Architectural Review Board Agenda
4:00 PM Wednesday, August 6, 2025
Sussex Civic Center – Committee Room Second Floor

MEMORANDUM

TO: Architectural Review Board
 FROM: Gabriel Gilbertson, Community Development Director
 RE: August 6, 2025 Architectural Review Board
 DATE: Friday, August 1, 2025

Client / Location or Project / Sign Classification / Version# or Sheet / Revision# / Drawing Status
Dynamic_Ratings_MON_v03_r03_D

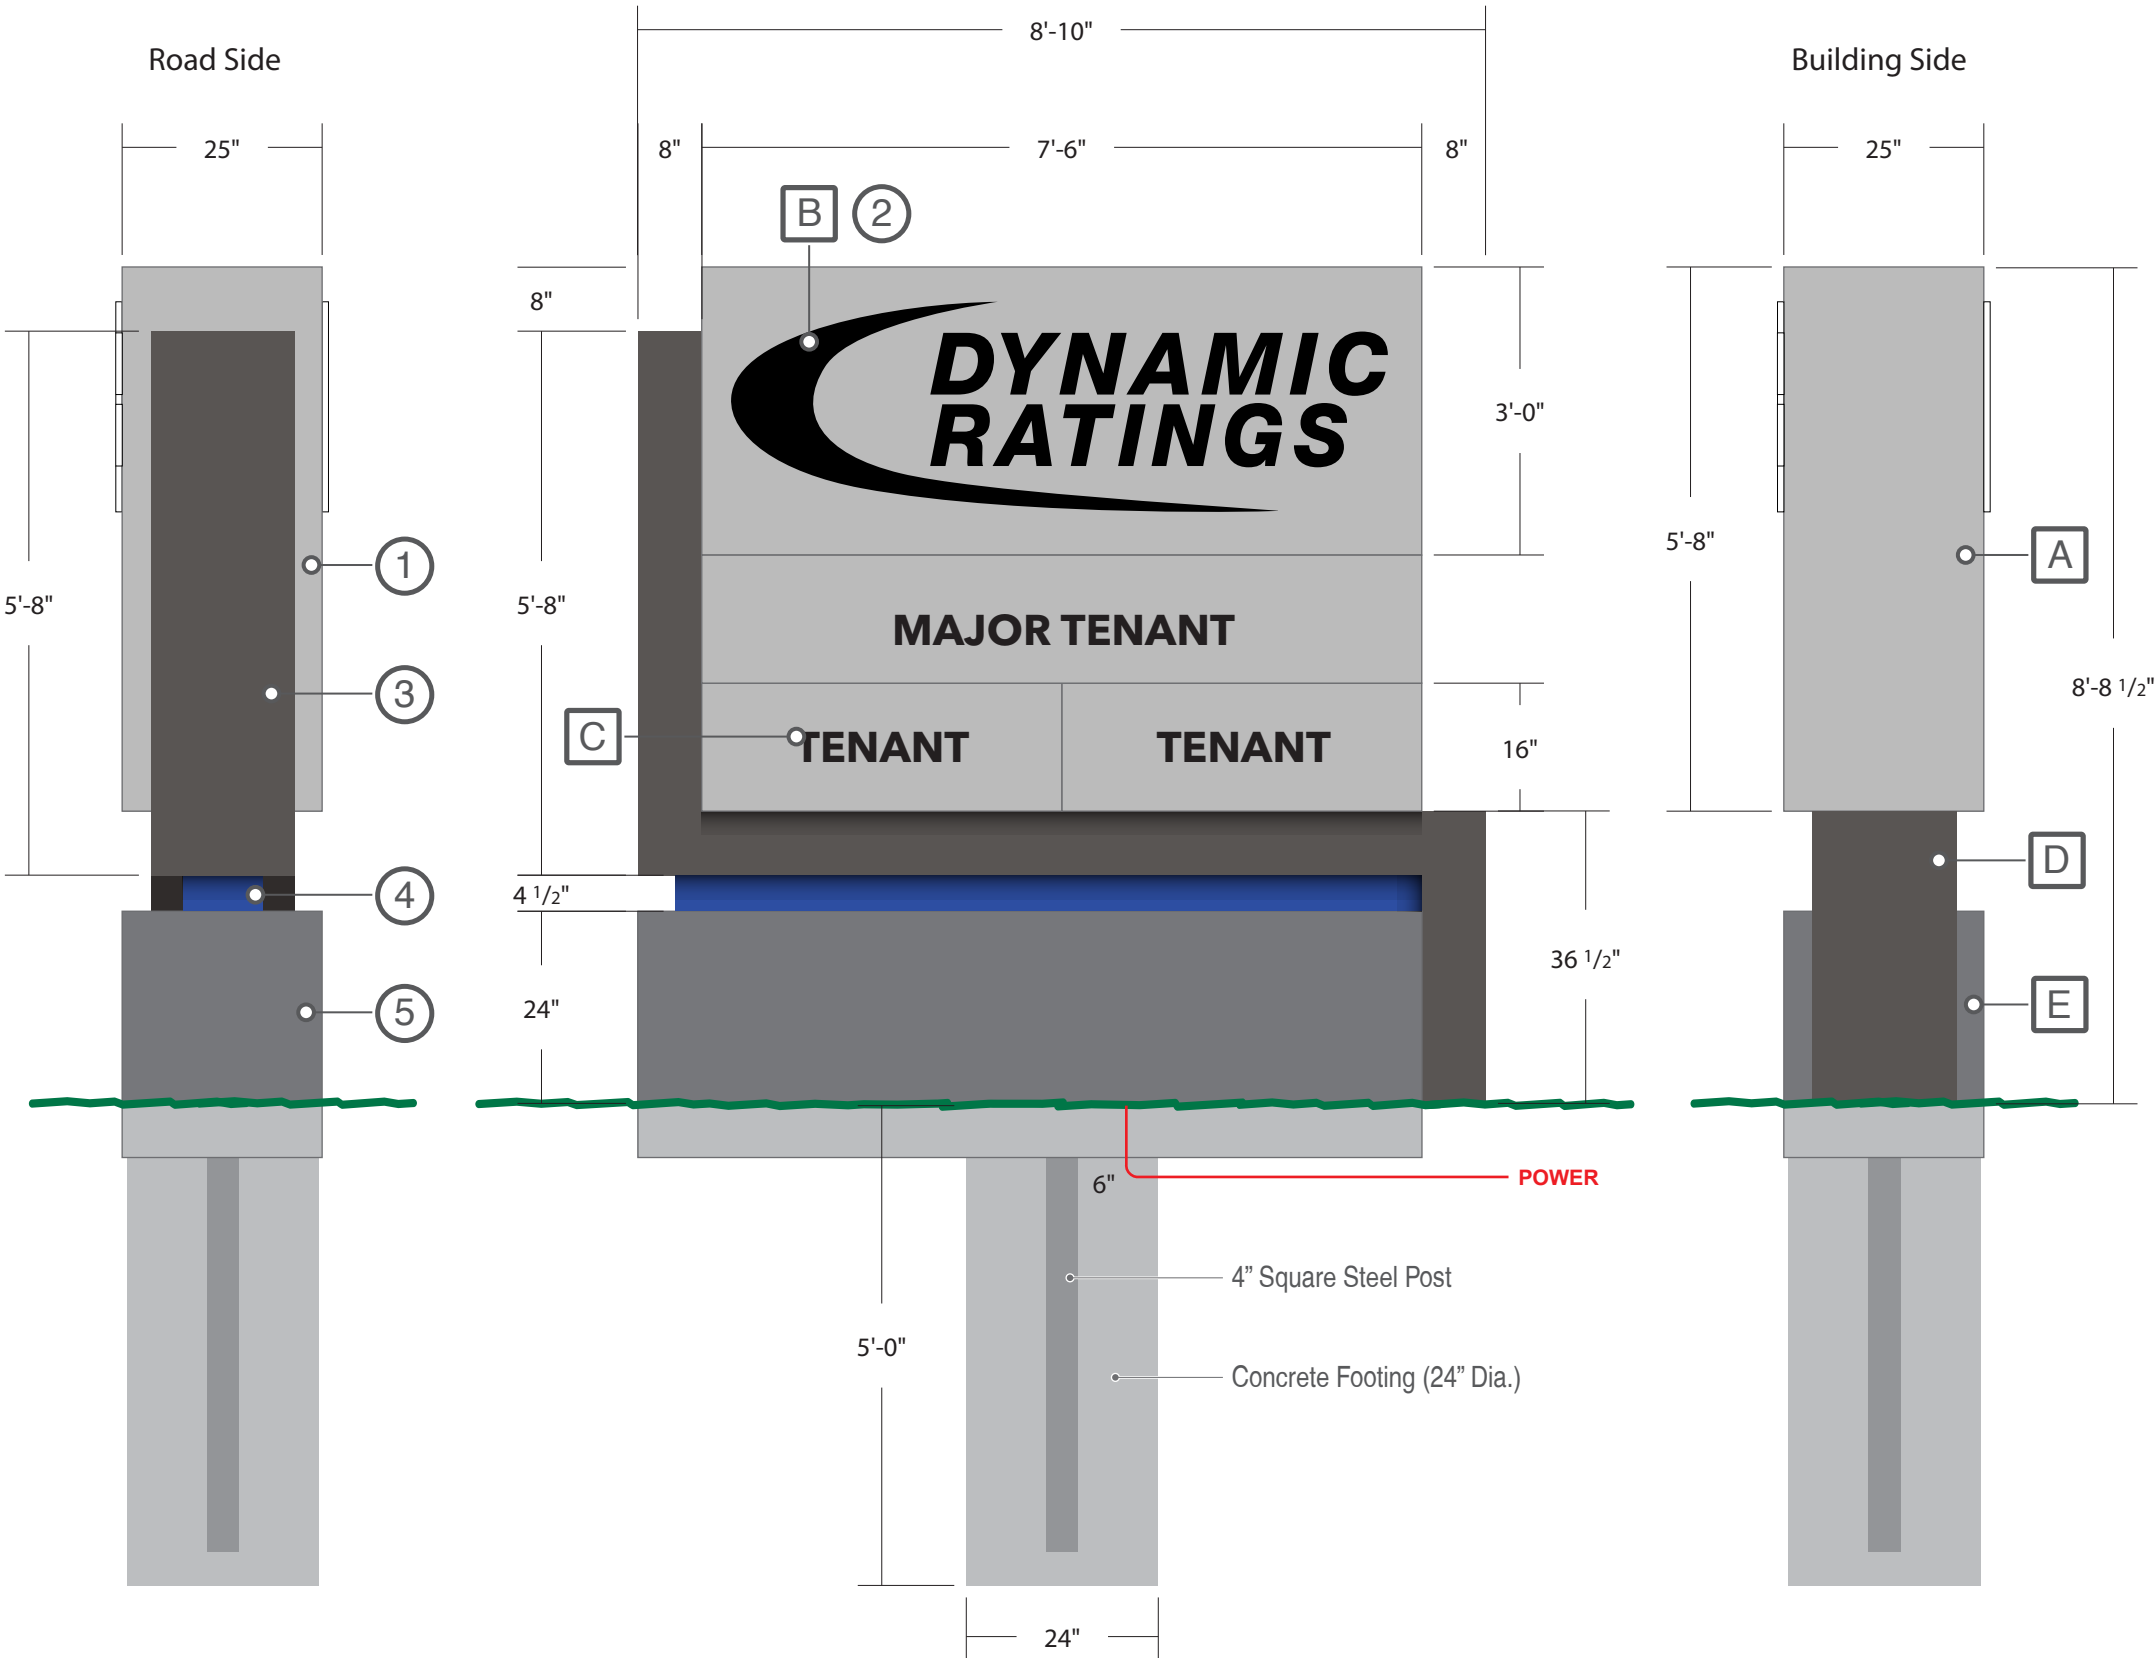
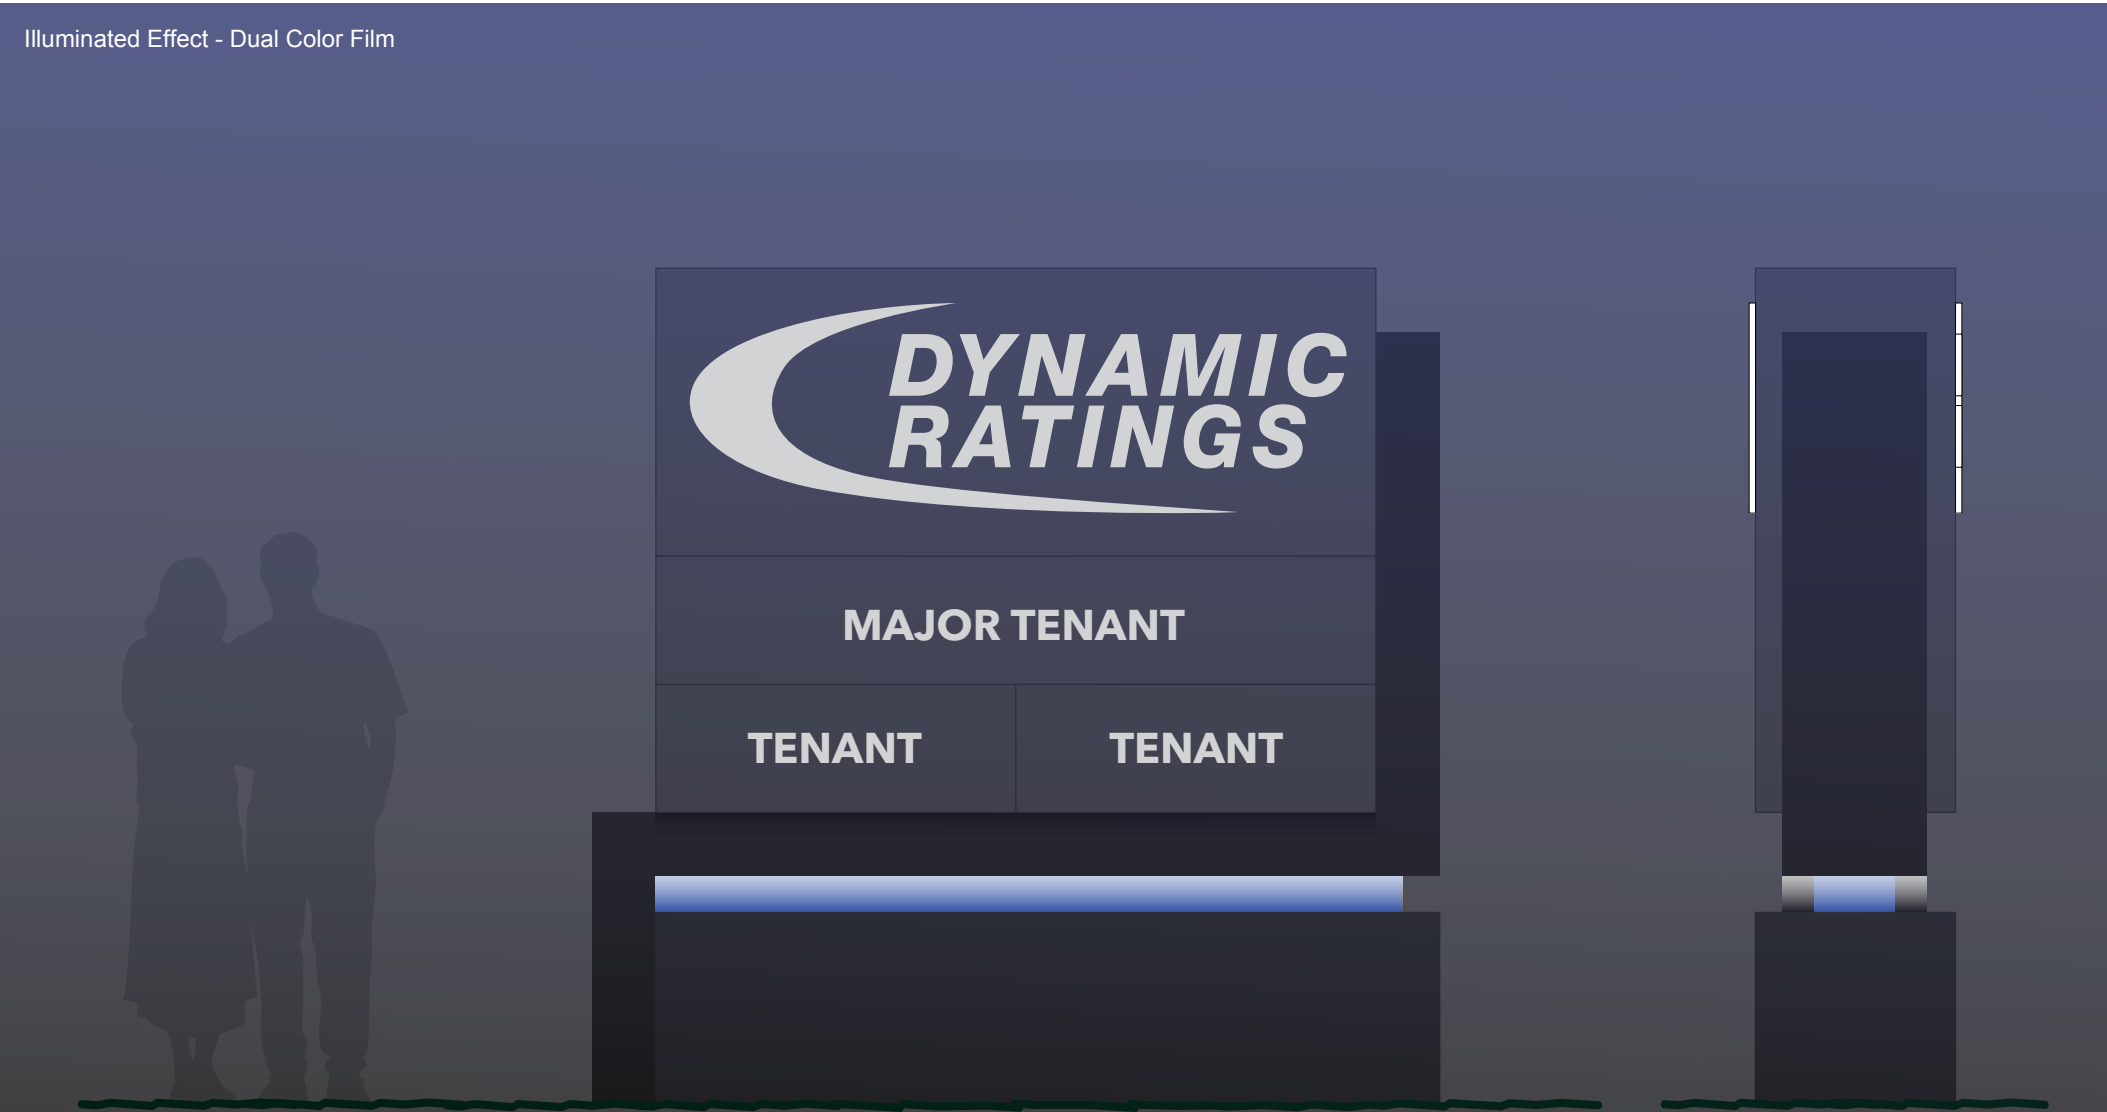
As a secondary plan, Lemberg/Dynamic Rating presents a second option. The second option is very similar in color, size, and design – however the base is now a concrete base that will be painted. This has been designed to honor the original design while also complying with the natural material ARB requirement. Please note, with this intentional design to match the building, it is difficult to have the natural material surrounding the sign cabinet.

SITE PLAN

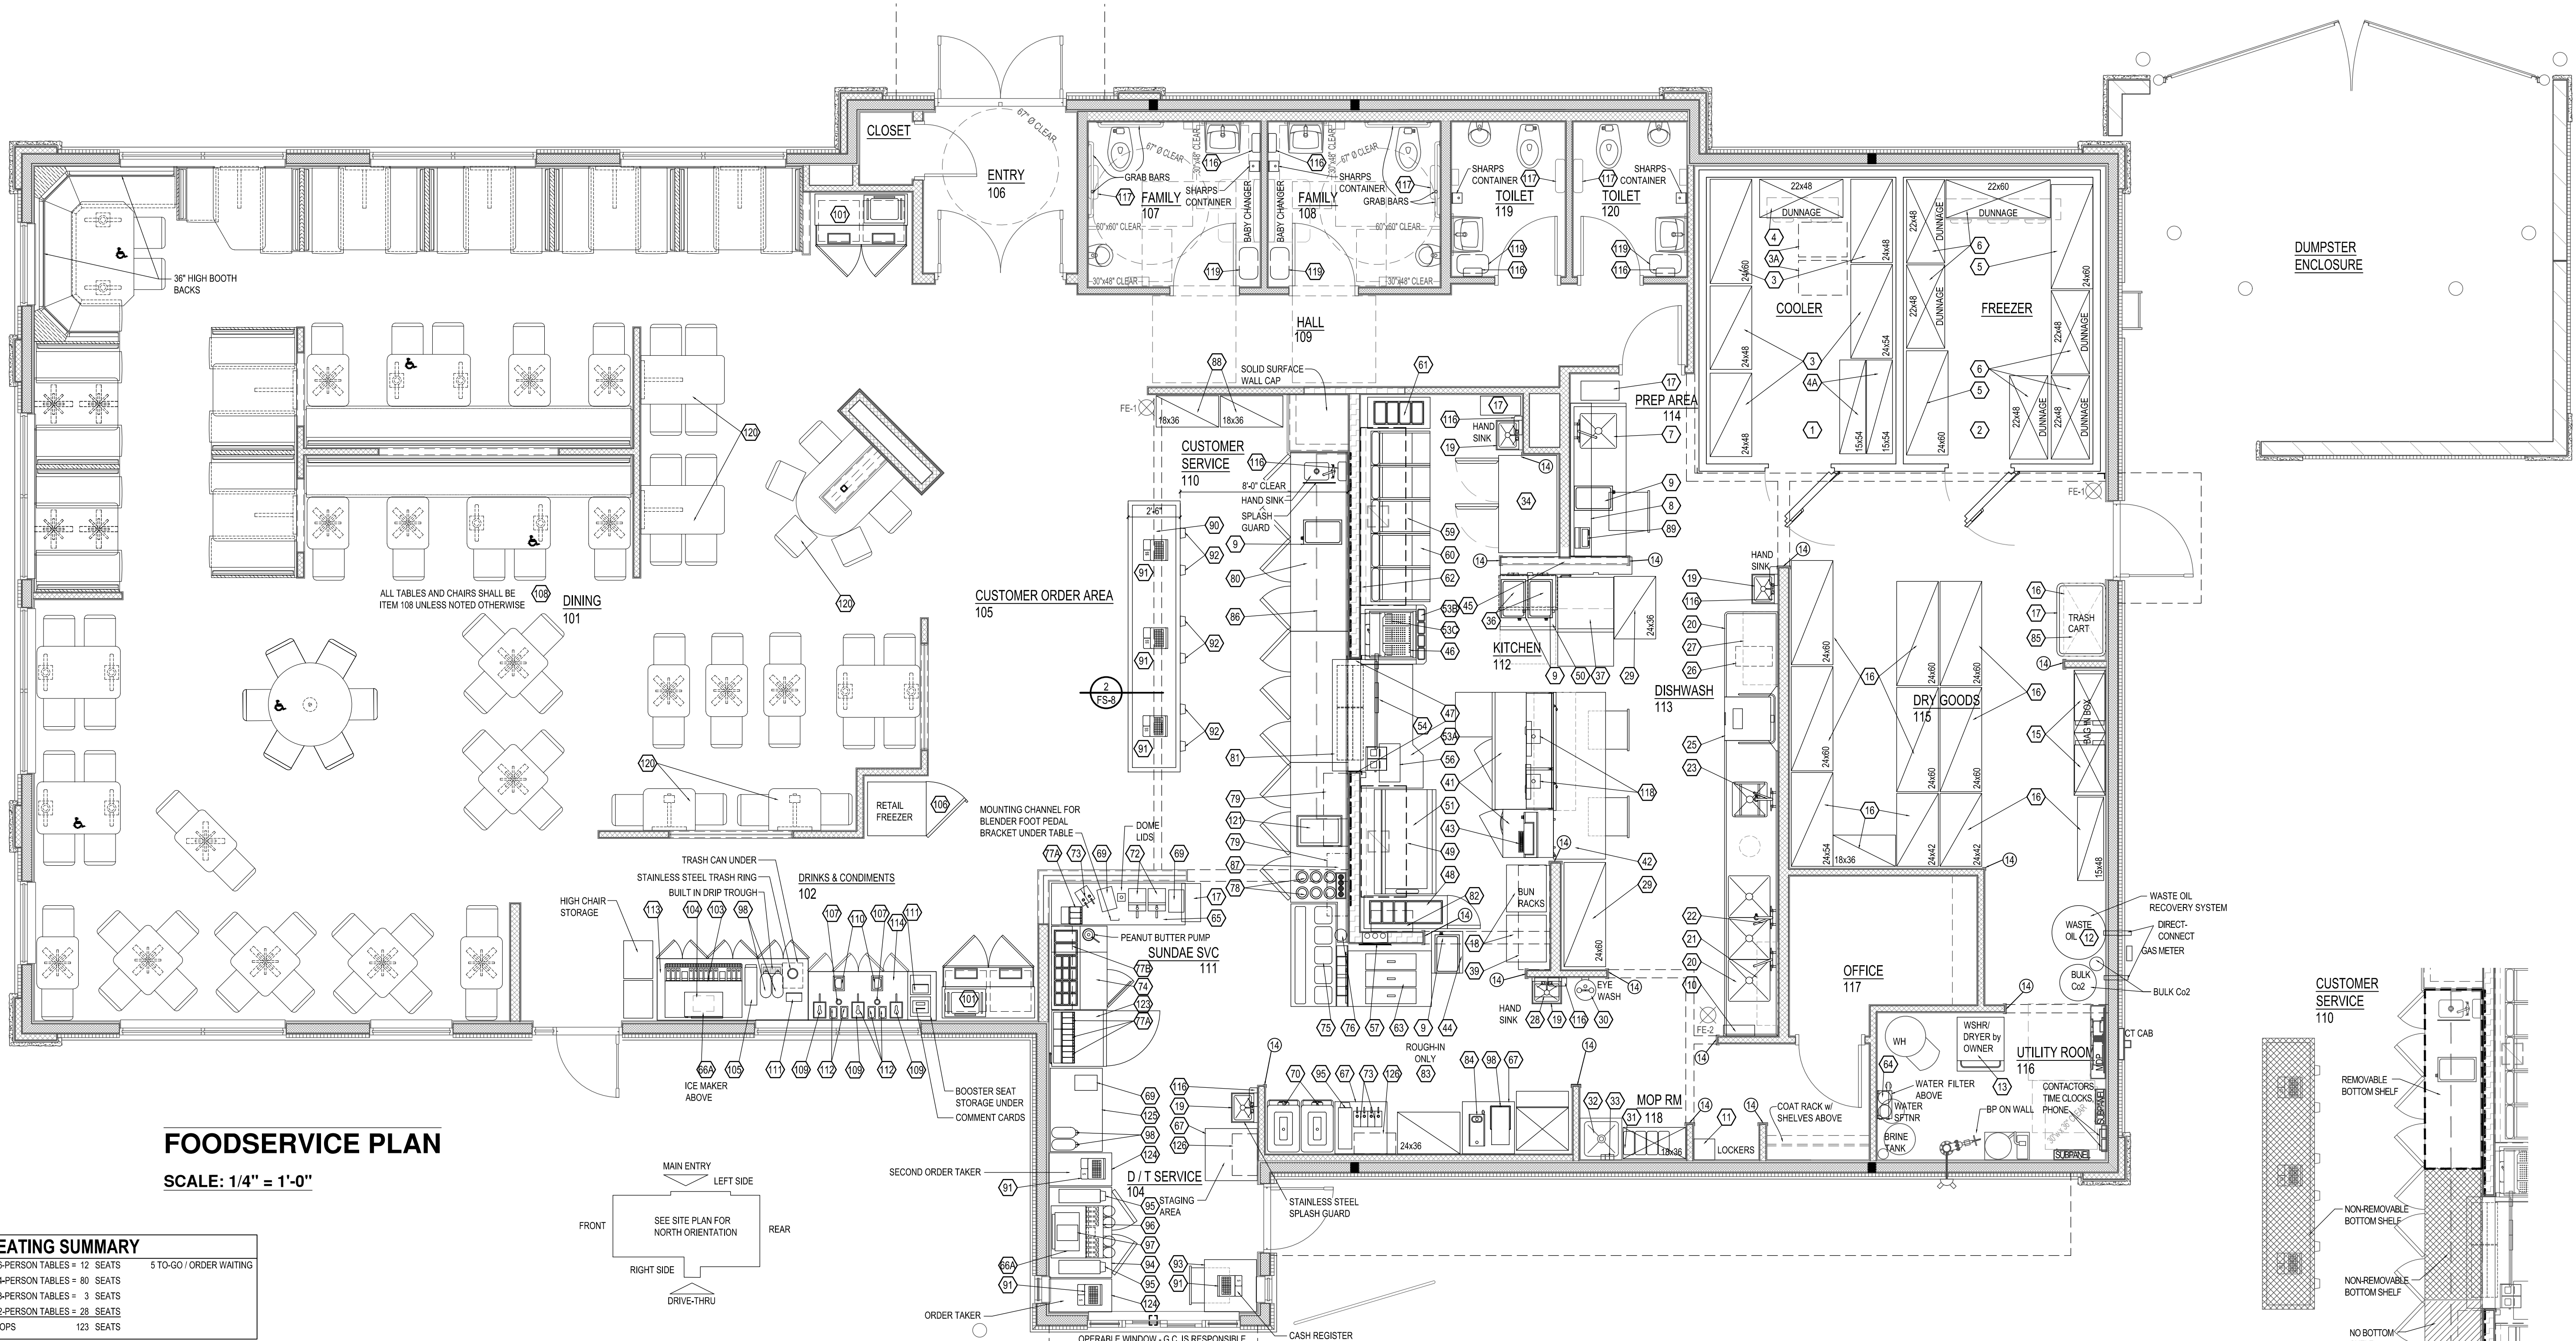
- Green space calculations need to be submitted to the Village for review.
- Site to have 96 parking stalls and will meet the minimum code requirements

1. Submitting a revised site plan with details for amount of greenspace.
2. Light fixture mounting height shall not exceed 25’.
3. Submitting revised elevations for the west side that meets the minimum 33% window and door opening requirements.
4. Submitting a revised landscape plan that includes lists hardwood mulch rather than stone mulch.
5. Light pole bases shall be painted to match the building. Submit details to Staff for review.
